**20-COA-0134**  
**1452 Cherokee Rd.**

**Cherokee Triangle Architectural Review Committee**  
**Public Hearing**

**Bradley Fister, Historic Preservation Specialist**  
**Sept 02, 2020**

RENOVATION OF  
1452 CHEROKEE ROAD

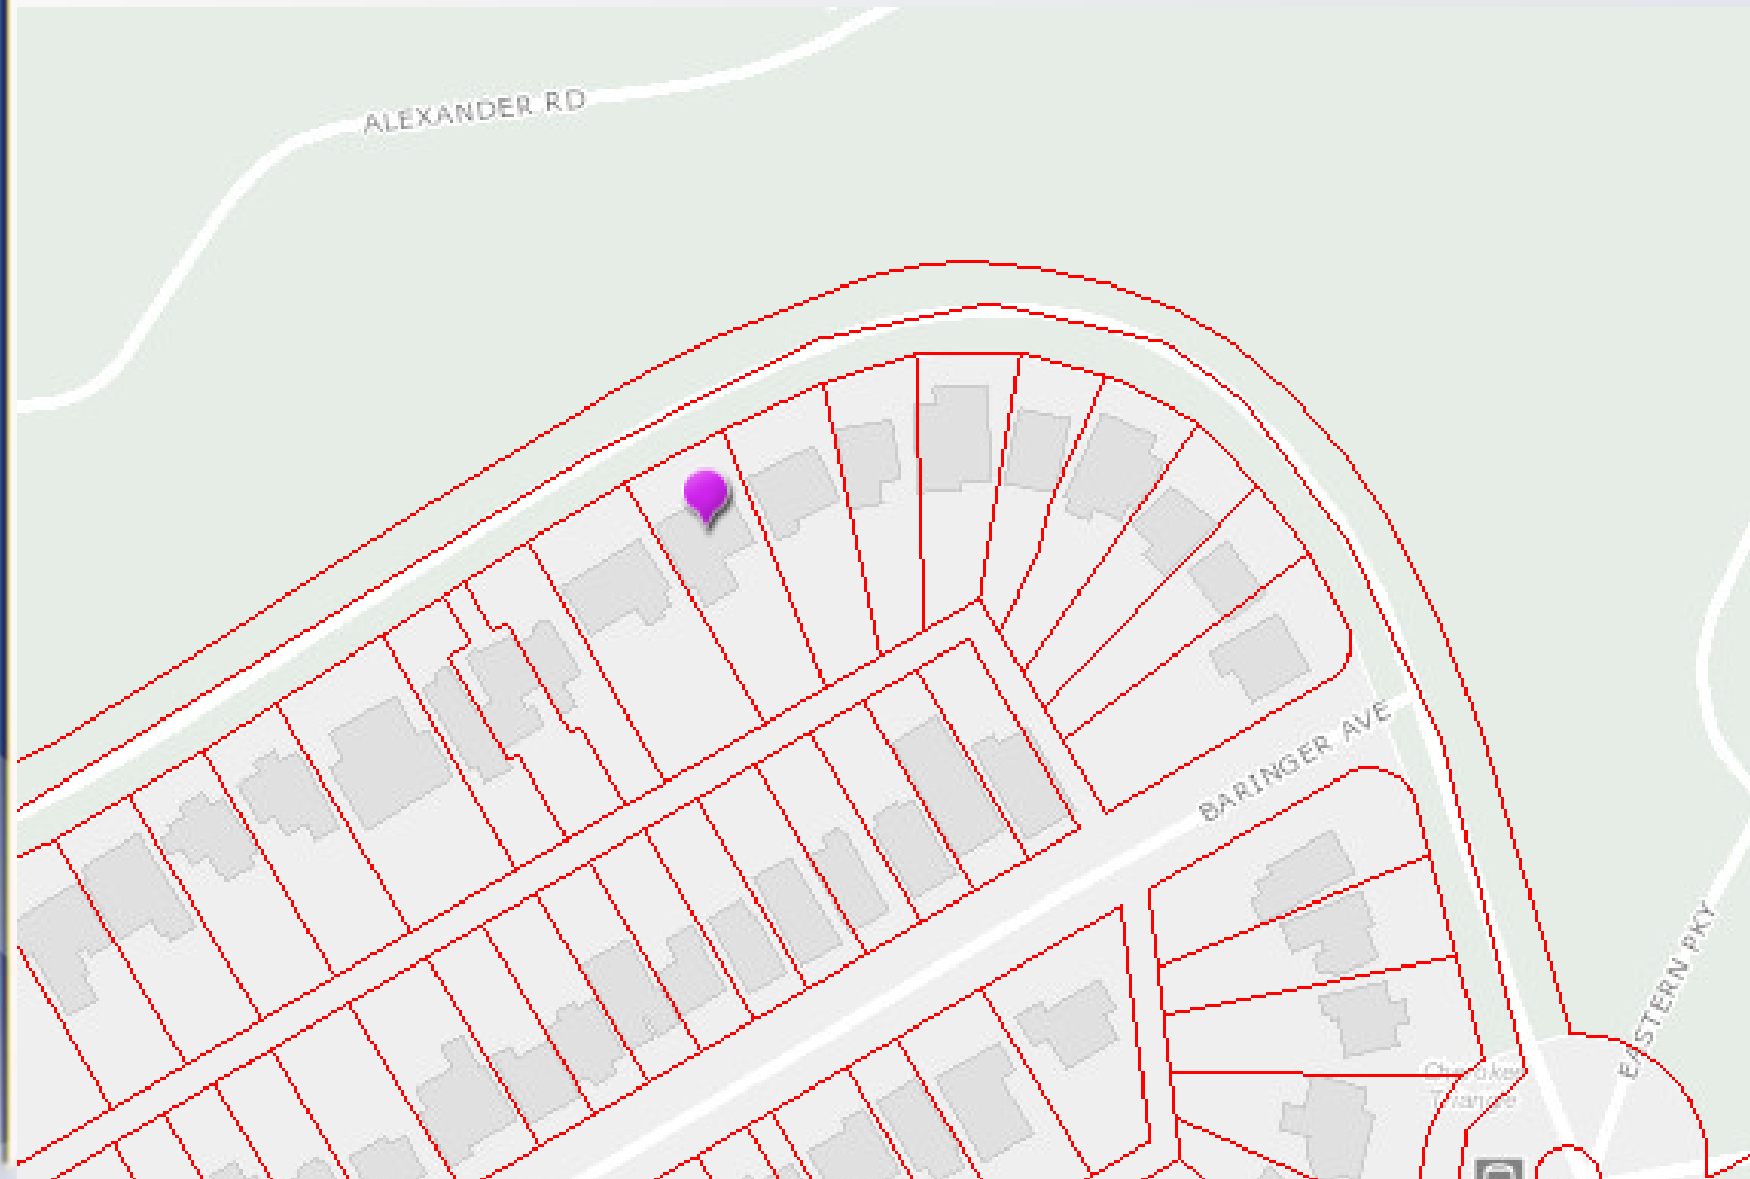
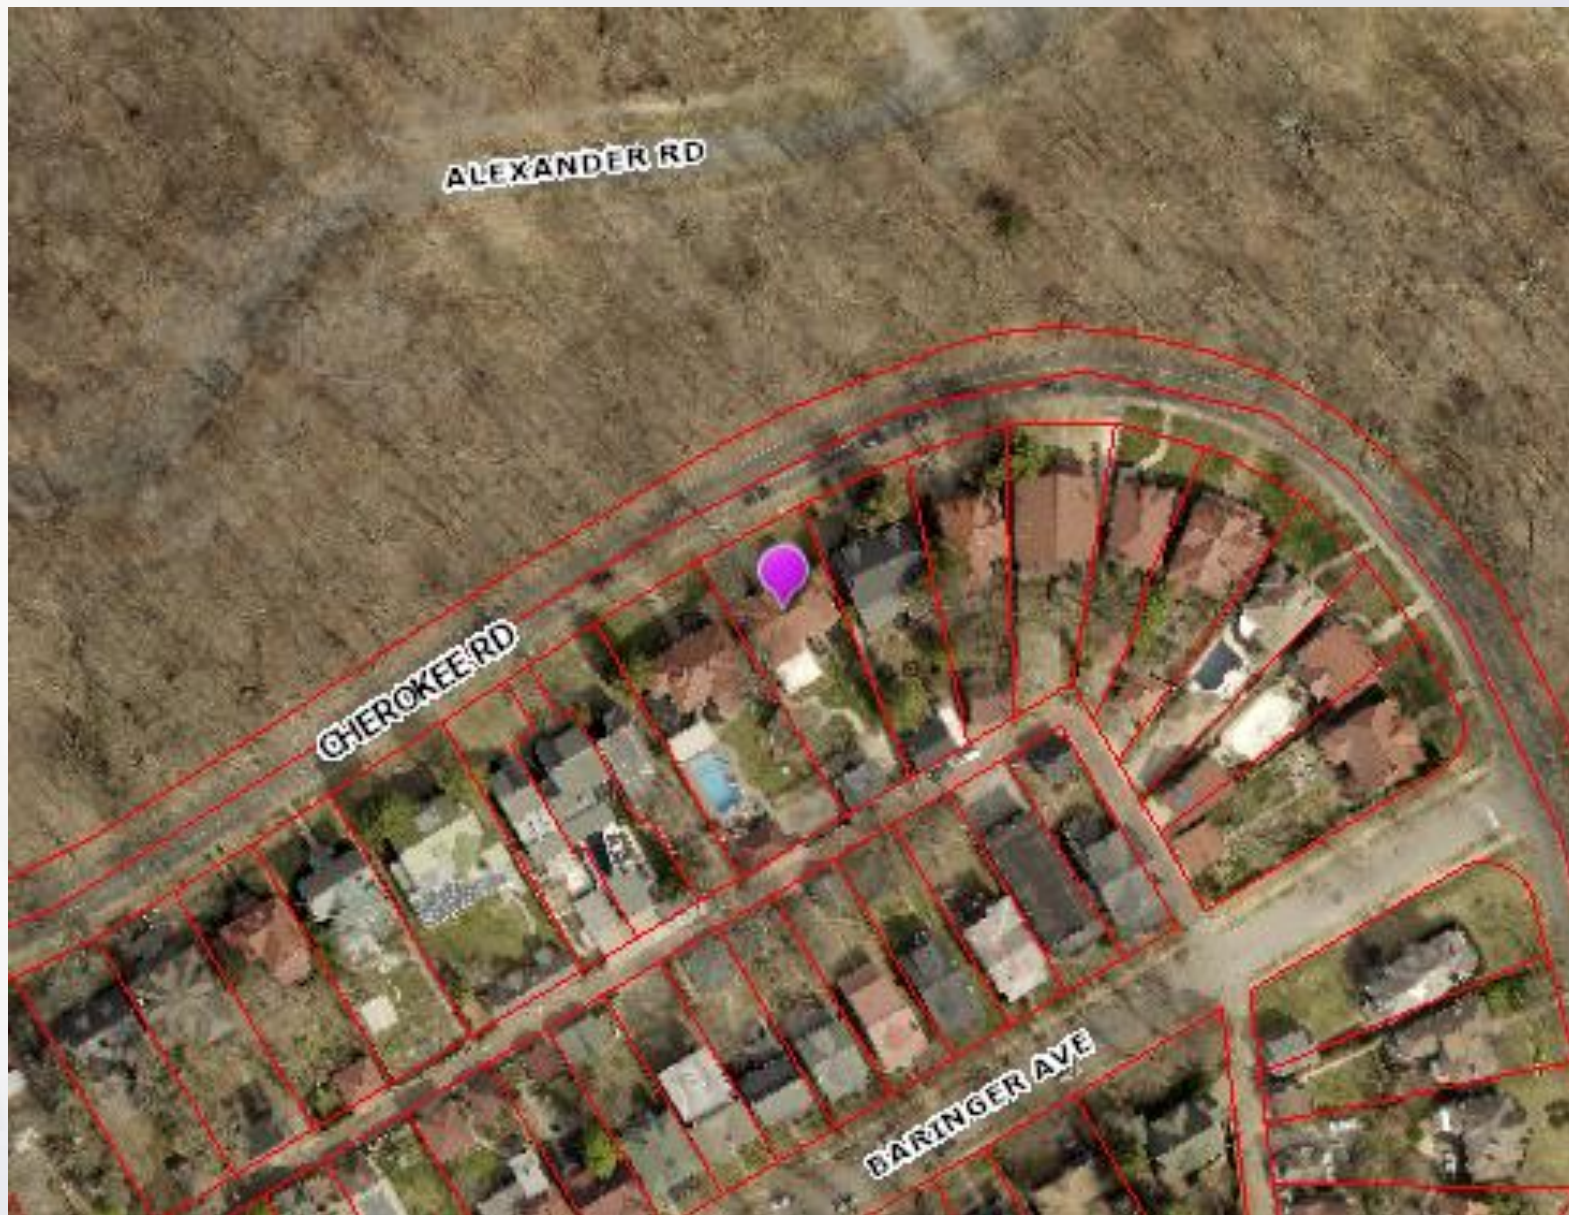
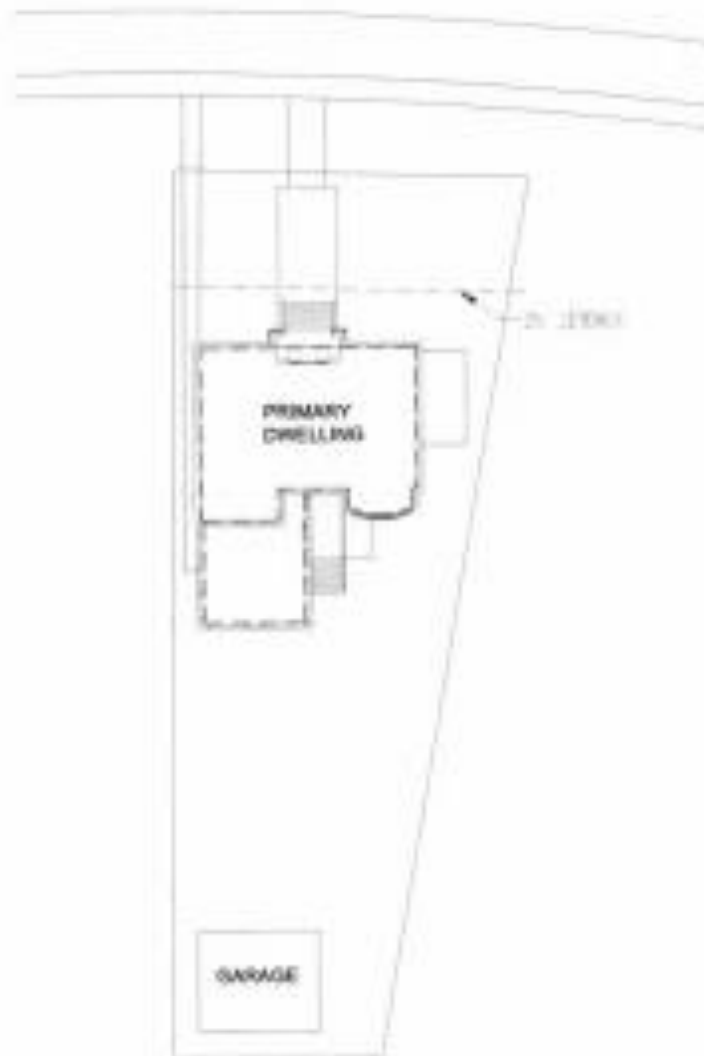
The applicant is applying to incorporate the construction of a low terrace into the existing stairs that lead to the front door of the house. The proposed 32'-0" wide terrace would be centered on the existing stairs and begin two steps down from the existing front porch (approximately 2' from grade level).

The terrace would extend outward toward the street from the foundation of the house approximately 11'-6". The foundation of the concrete terrace is proposed to be clad with stucco, while the perimeter is proposed to be cut limestone to mimic the design of the homes existing accents and foundation.

The proposed changes to the property generally meet the **Addition, Porch and Site** Design Guidelines for the Cherokee Triangle Preservation District, with the exception of the terrace proposed being constructed at the front of the home. Though it states in the Design Guidelines decks should not be constructed on front facades, this proposed terrace at the front of the home is not unusual on the street or the district as a whole.

The design and materials proposed for the terrace will be complimentary to the architecture and would not be considered a deck. Therefore, staff recommends that the proposed work is appropriate for this property at this time.

Based on the information furnished by the applicant, the application for a Certificate of Appropriateness is approved with the following conditions:

1. If the design or materials should change, the applicant shall contact staff for review and approval prior to any work taking place.
2. The applicant shall use historic concrete mix for any newly poured concrete.

- 3.The addition of the handrail to the front stairs shall be presented to staff for approval prior to installing.**
- 4.The applicant shall take precautions not to disturb the foundation of the house.**
- 5.The applicant and/or their representative shall obtain any permits necessary to begin the work.**

## PROPOSED FRONT ELEVATION

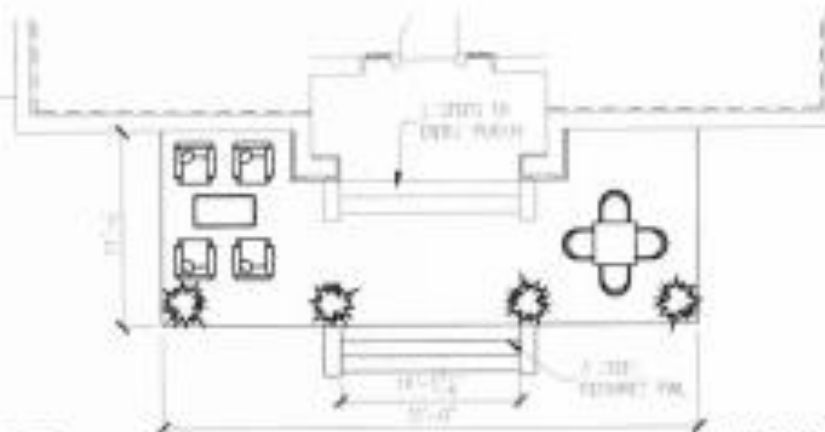
SEE PLAN  
RETURNED TO  
CODE AT THIS  
HEIGHT
